STAFF REPORT
COMMUNITY DEVELOPMENT DEPARTMENT

HEARING DATE: December 14, 2021
 TO: Mayor & City Council
 FROM: Sonya Allen, Associate Planner
 208-884-5533
 SUBJECT: H-2021-0065
 Aviator Springs – AZ, PP
 LOCATION: 3235 N. McDermott Rd., in the SE ¼ of Section 32, T.4N., R.1W. (Parcels #R7824220044 & #R7824220042)

B. Preliminary Plat & Phasing Plan (date: 9/3/2021-12/2/21) - Revised

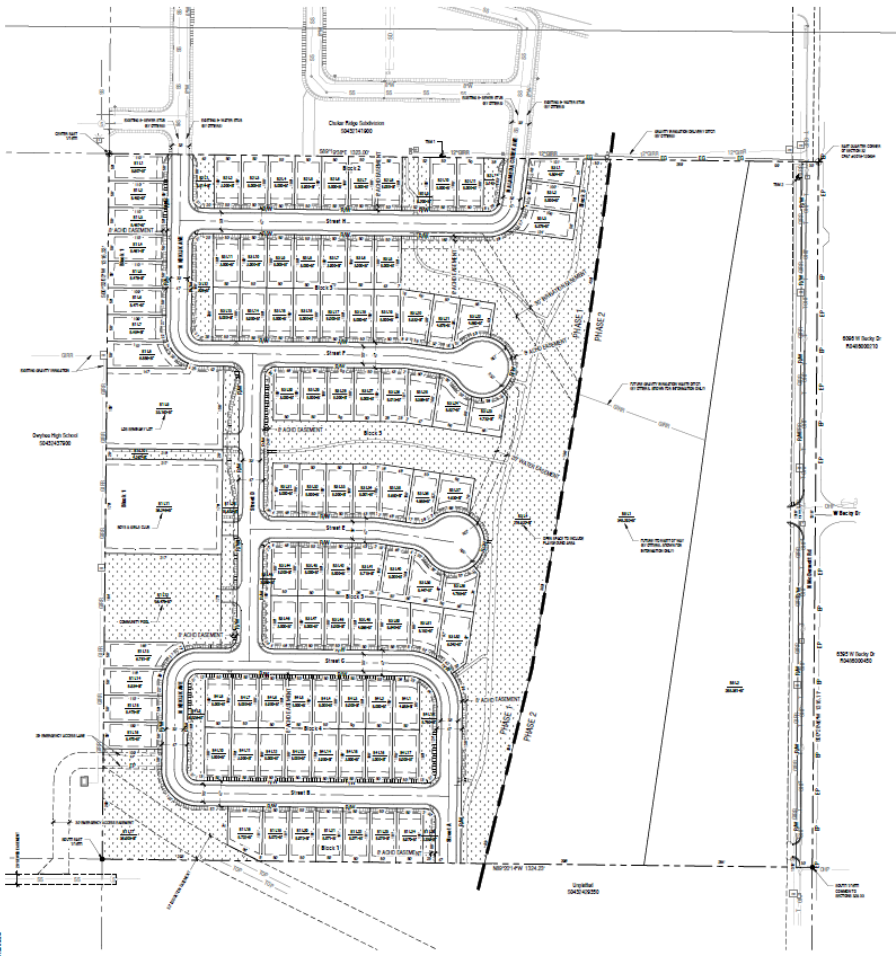
Access is proposed to the western portion of the development via the extension of two (2) local streets from the north from Chukar Ridge Subdivision. A temporary emergency access easement has been granted to the subject property by WASD through the school property until such time as another acceptable secondary access is provided to the site that meets Fire Dept. requirements. Future SH-16 is planned to bisect this site on Lot 1, Block 5. Access is proposed to the eastern portion of the site via N. McDermott Rd. Direct access via future SH-16 is prohibited. One (1) stub street is proposed to the south for future extension and interconnectivity.

Typically, a street generally paralleling the state highway is required with development to provide connectivity and access to all properties fronting the state highway that lie between the Applicant's property and the nearest section line road and/or half mile collector road. Because the developments to the north (i.e. Chukar Ridge & Gander Creek) did not provide such a road, Staff is not requiring one with this development. The stub street to the south is located at the back edge of the street buffer along future SH-16, which can be extended to the south to Ustick Rd. in accord with UDC 11-3H-4B.3.

The Pathways Master Plan does not depict any required multi-use pathways on this property. A 10' wide multi-use pathway is proposed within the common open space area adjacent to future SH-16. **The pathway is required to be placed in a 14-foot wide public use easement, which shall be submitted to the Planning Division prior to submittal for City Engineer signature on the final plat(s) for Phase 1.**

C. Landscape Plan (date: 9/3/2021)

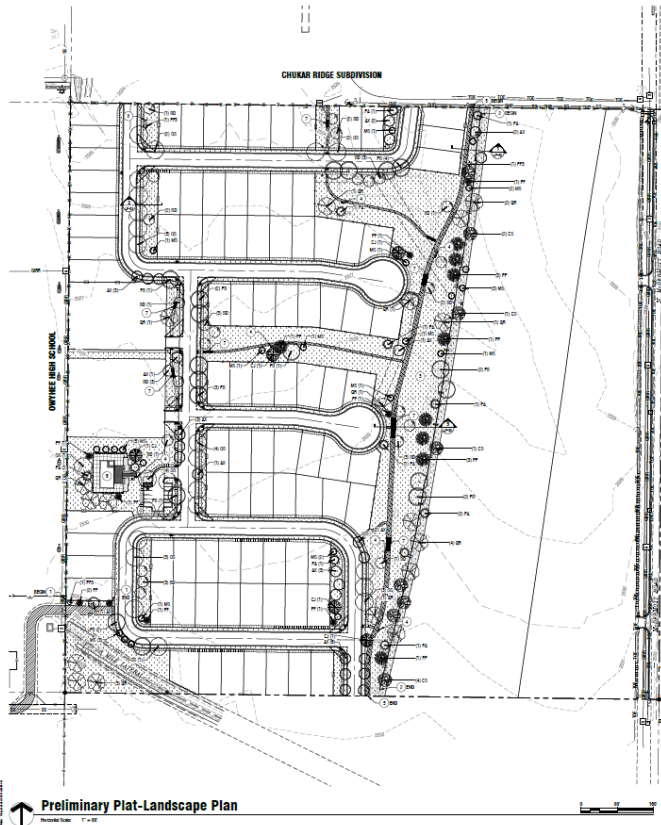
A 35-foot wide street buffer is required on both sides of future SH-16, a state highway and entryway corridor. Landscaping is required to be installed within the buffer per the standards listed in [UDC 11-3B-7C](#), which require a *mix* of trees and shrubs, lawn, or other vegetative groundcover – shrub should be included in the buffer in accord with this standard. A dense buffer is proposed on the west side of future SH-16 consisting of a mix of deciduous & coniferous trees; **shrubs should be added as required by UDC 11-3B-7C. No buffer is depicted on the east side of future SH-16; a minimum 35-foot wide street buffer is required in a common lot or a permanent dedicated buffer with landscaping included on the landscape plan in accord with UDC standards.**

Common open space is required to be landscaped in accord with the standards listed in UDC 11-3G-3E. At a *minimum*, one tree per 8,000 square feet of common area is required to be provided along with lawn or other vegetative groundcover. Landscaping is proposed in *excess* of UDC standards as shown on the landscape plan in Section VII.C.

Landscaping is required adjacent to all pathways per the standards in UDC [11-3B-12C](#). A 5' wide landscape strip is required on both sides of pathways planted with a *mix* of trees, shrubs, lawn and/or other vegetative ground cover. **The Landscape Requirements table should include the linear feet of pathway with the required vs. proposed number of trees to demonstrate compliance with UDC standards.**

Noise abatement is required for residential uses adjoining a state highway. A berm or berm and wall combination is required to be constructed parallel to the state highway that meets the standards listed in UDC 11-3H-4D. A 6-foot tall fence/wall is proposed on the landscape plan that does *not* meet the required standards as there is no berm proposed.

In accord with City Council's direction on previous developments to the north (i.e. Chukar Ridge & Gander Creek subdivisions), Staff recommends a 6-foot tall berm with a 6-foot tall wall on top of the berm is constructed within the buffer along future SH-16. The berm/wall is required to be a minimum of 10-feet higher than the elevation at the centerline of the state highway; the wall must meet the standards in UDC 11-3H-4D.3. A detail of the proposed berm/wall combination that demonstrates compliance with the standards listed in UDC 11-3H-4D and as recommended by Staff should be ~~was~~ submitted with the final plat for the first phase of development after the Commission hearing. Alternative compliance may be approved by the Director as set forth in UDC 11-5B-5 where the applicant has a substitute noise abatement proposal in accord with ITD standards and prepared by a qualified sound engineer per UDC 11-3H-4D.4.

- b. Include a note prohibiting access to future SH-16.
 3. The landscape plan submitted with the final plat shall be revised as follows:
 - a. Add Class II trees and landscaping within all parkways within the development in accord with the standards listed in UDC 11-3A-17E and 11-3B-7C as desired in MU-N designated areas.

- d. Include a detail of the berm or berm and wall combination required for noise abatement along future SH-16 that demonstrates compliance with the standards listed in UDC 11-3H-4D and is consistent with what City Council required on previous developments to the north (i.e. Chukar Ridge & Gander Creek – a 6-foot tall berm with a 6-foot tall wall on top of the berm); or apply for alternative compliance as allowed by UDC 11-3H-4D.4 as set forth in UDC 11-5B-5.
